**Florida
Power**
CORPORATION

Subject: Crystal River Unit 3
Docket No. 50-302
Operating License No. DPR-72
Technical Specification Change Request No. 39

Revisions to Technical Specification Change Request No. 39 for (1) 2452 Mwt versus 2544 Mwt; (2) deletion of the Reactor Coolant Power Pump Monitors; and (3) Item 5 of IE Bulletin 79-05B.

FIGURE 2.1-1
REACTOR CORE SAFETY LIMIT

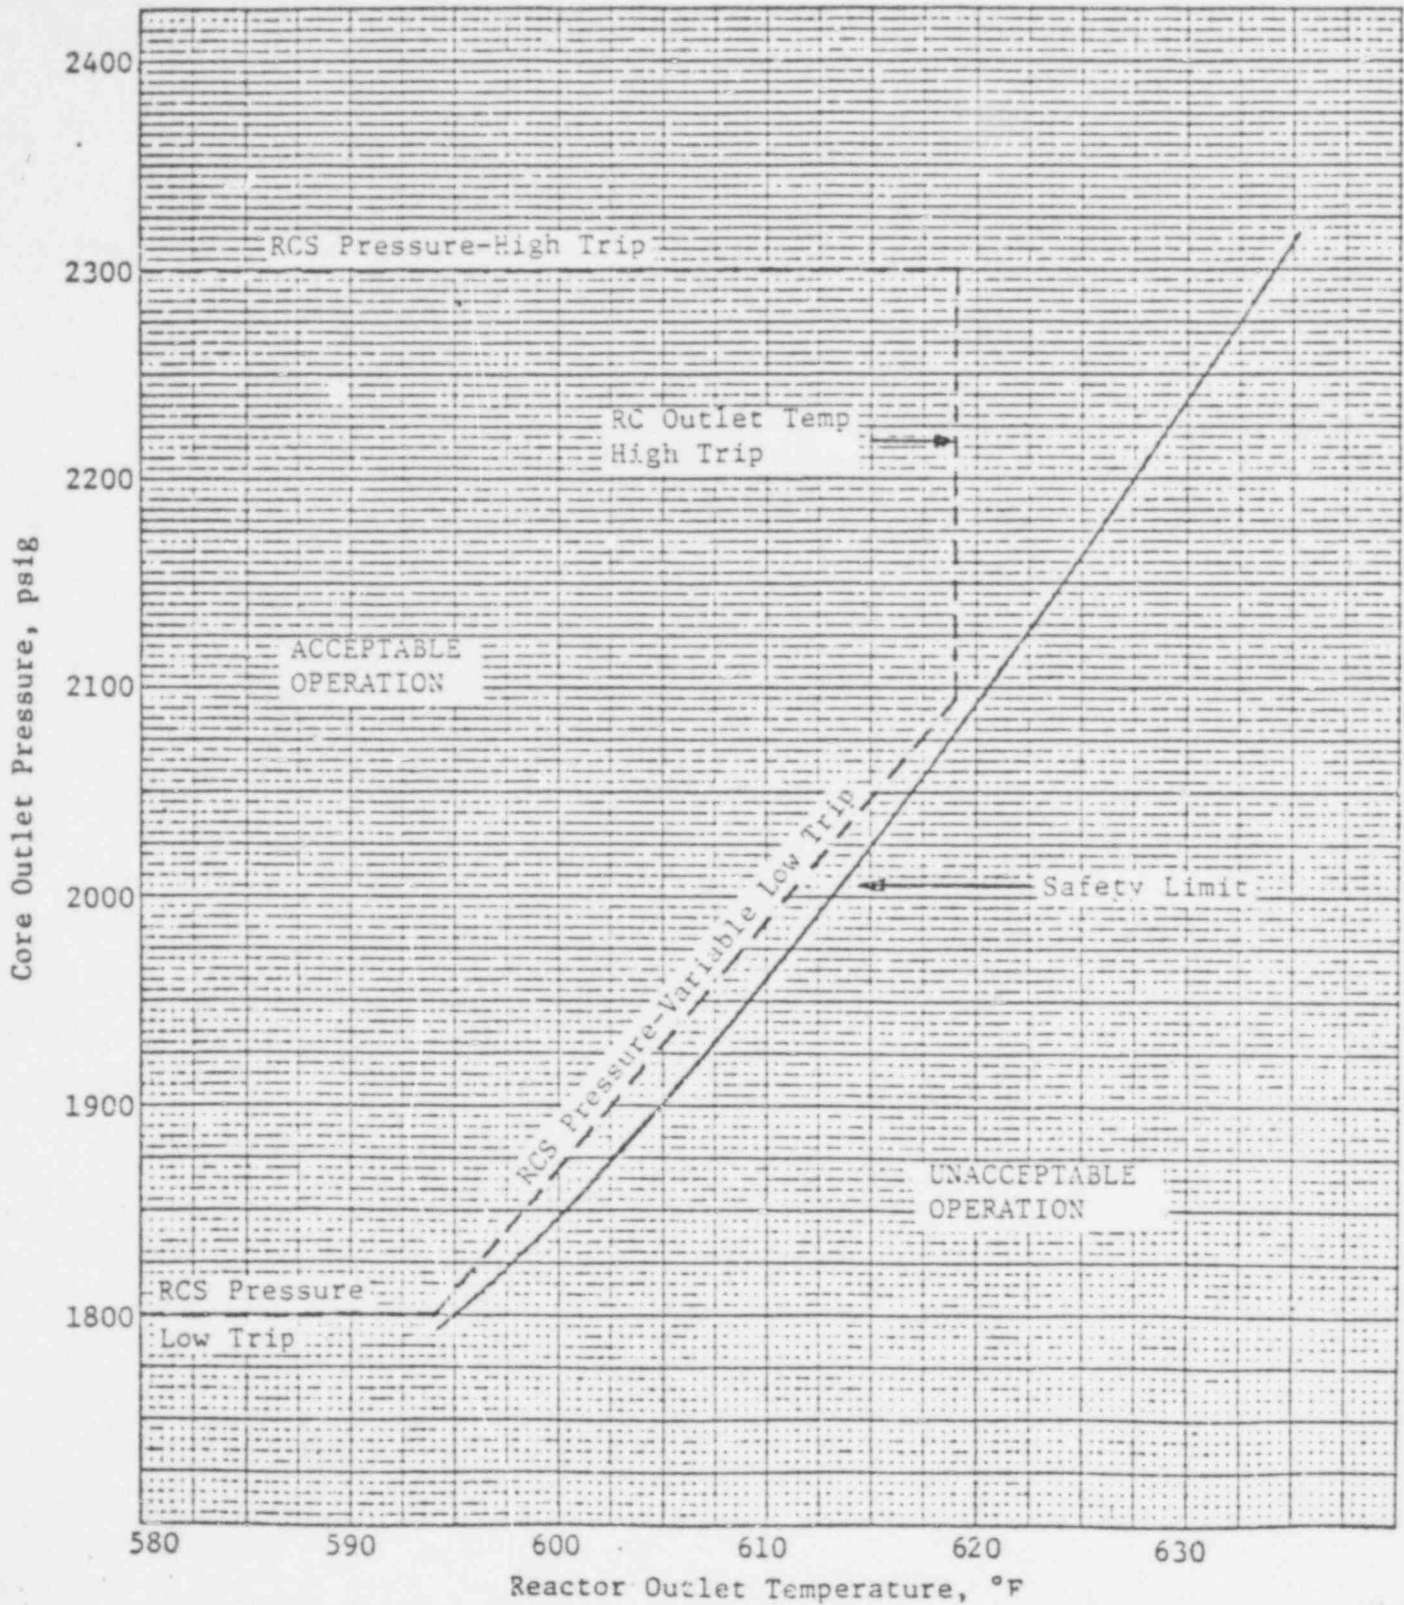
- Page 2-2: In Figure 2.1-1, the RCS Pressure-High Trip should be redrawn as 2300 psig instead of 2355 psig.
- Page 2-3: In Figure 2.1-2, the limit line for acceptable 3 & 4 pump operation should be lowered by 2.0% of RATED THERMAL POWER.

BASES FIGURE 2.1

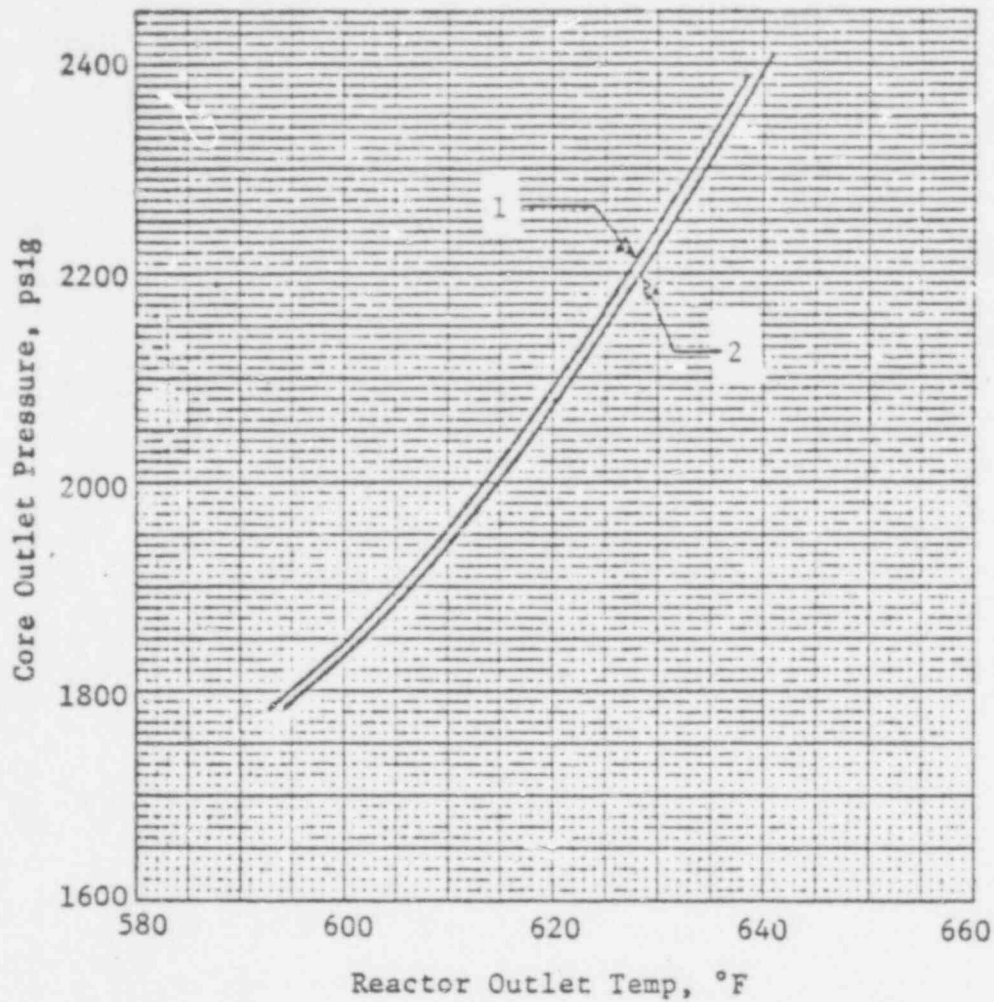
- Page B2-8: For Curves 1 and 2, change the Power (% RTP) to 117.3% and 90.5%, respectively, instead of 113.1% and 87.2%, respectively.

FIGURE 3.1-1

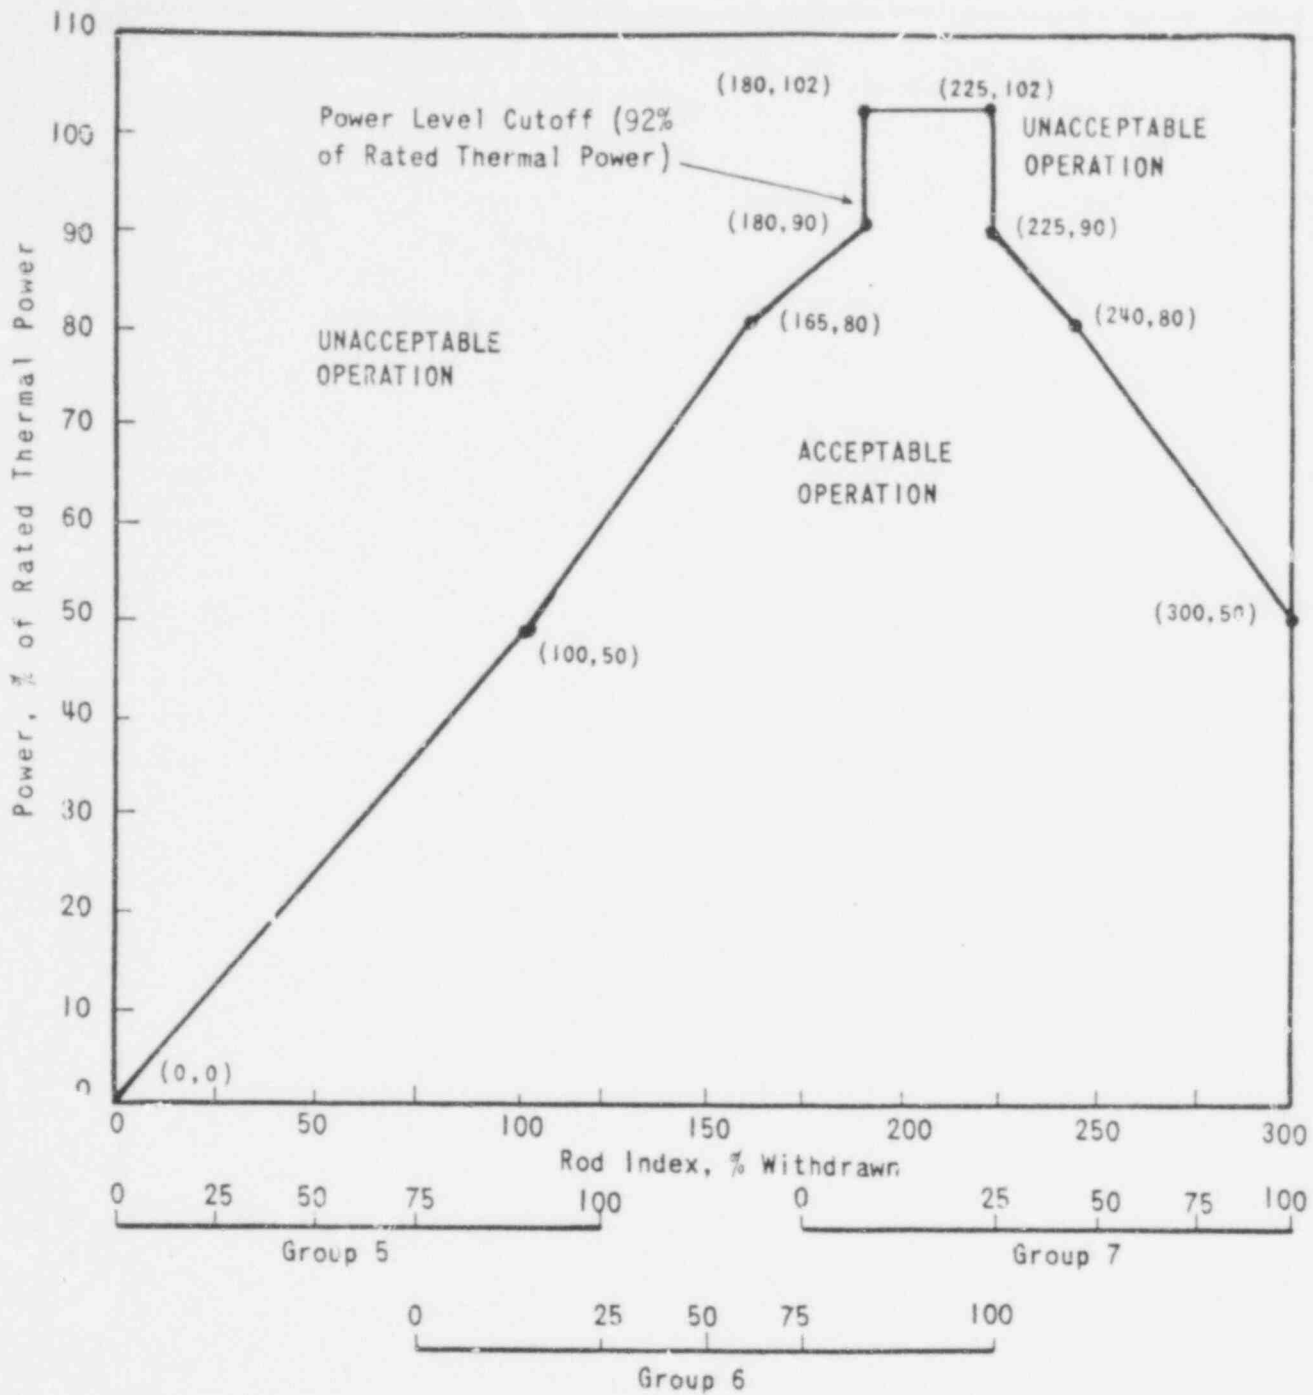
- Page 3/4 1-27: In Figure 3.1-1, change the Power Level Cutoff to 92% of Rated Thermal Power instead of 90%.
- Change the length of mid-Cycle 2 to 233 ± 10 EFPD instead of 225 ± 10 EFPD.

FIGURE 3.1-2

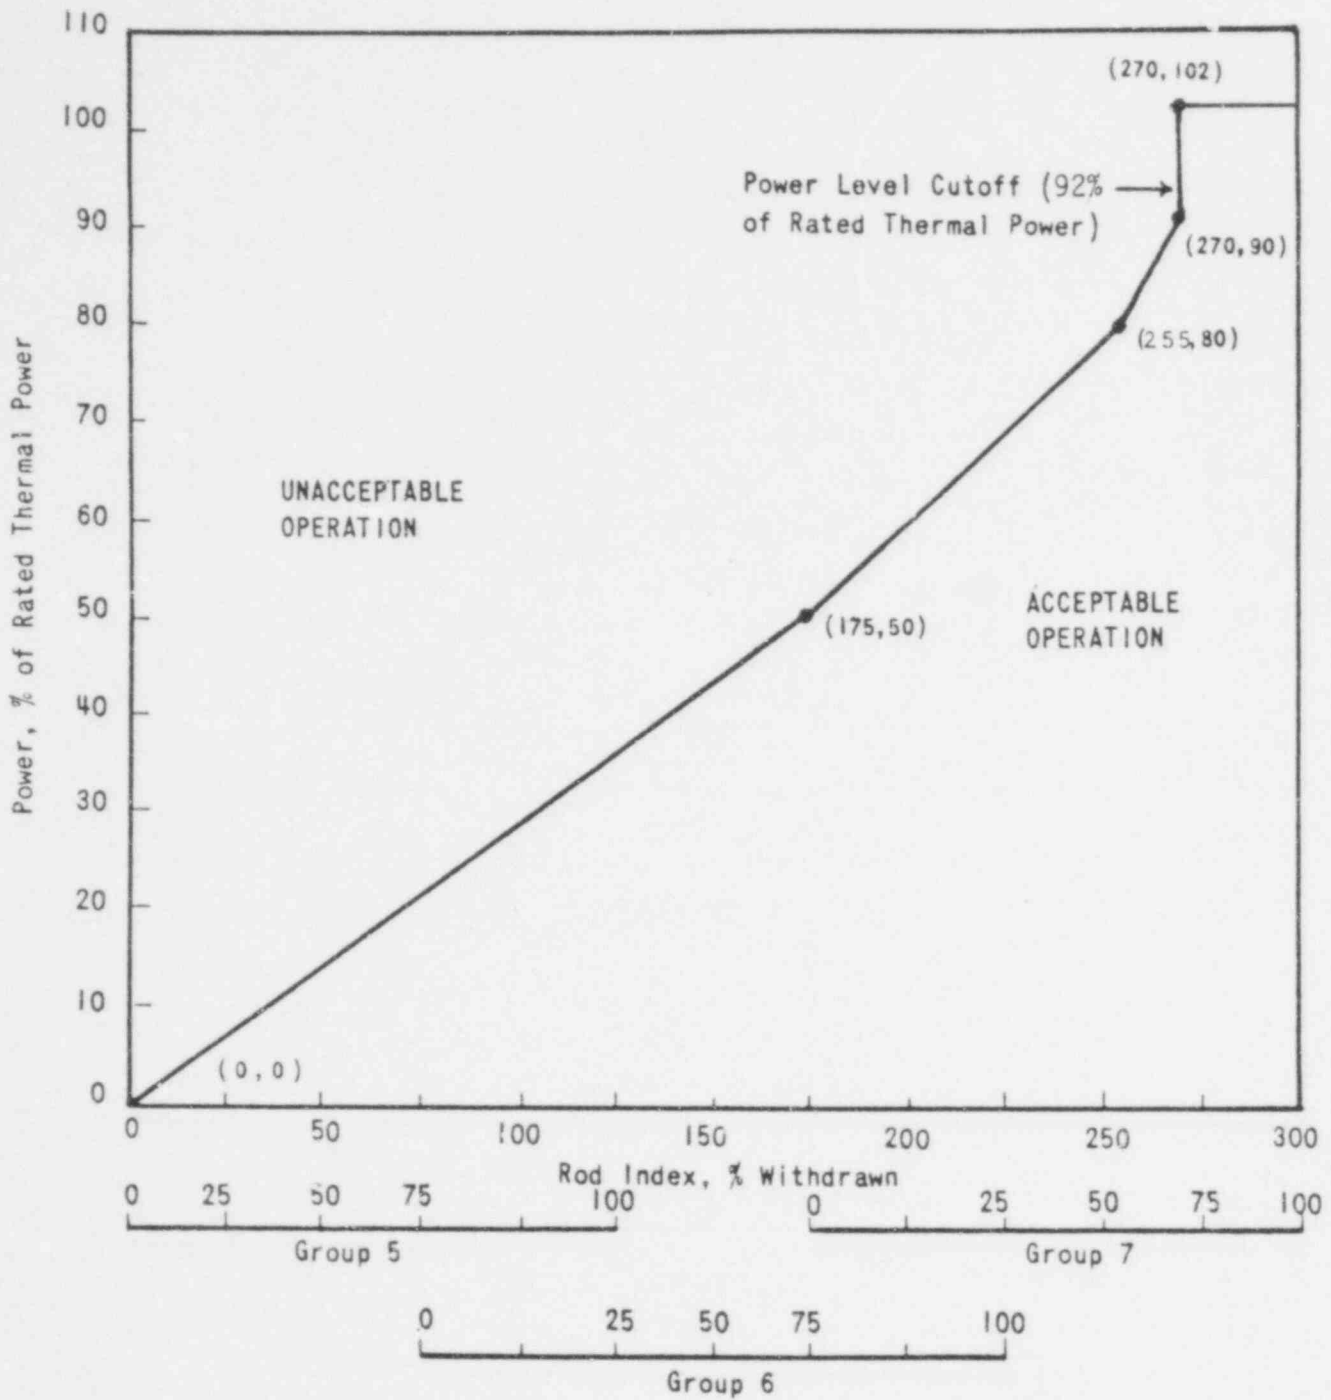
- Page 3/4 1-28: In Figure 3.1-2, change the Power Level Cutoff to 92% of Rated Thermal Power instead of 90%.
- Change the length of mid-Cycle 2 to 233 ± 10 EFPD instead of 225 ± 10 EFPD.

FIGURE 3.2-2

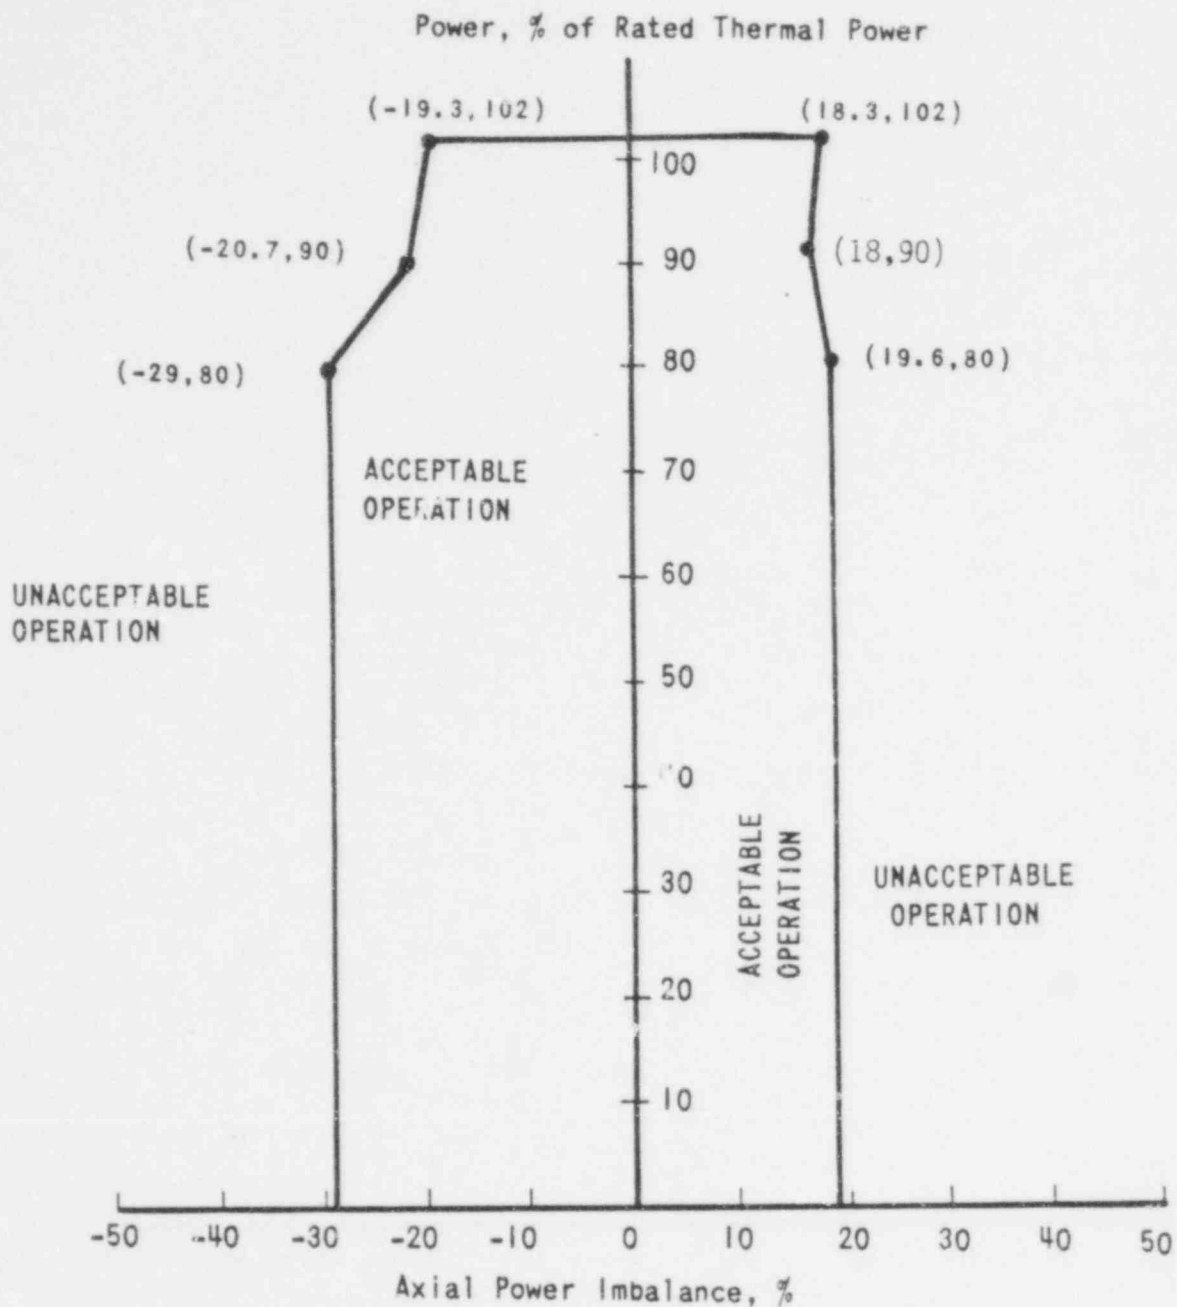
- Page 3/4 2-2: Change the length of mid-Cycle 2 to 233 ± 10 EFPD instead of 225 ± 10 EFPD.
- Page 3/4 2-3: In Figure 3.2-2 the point defined as (18, 92) should be changed to (18, 90).
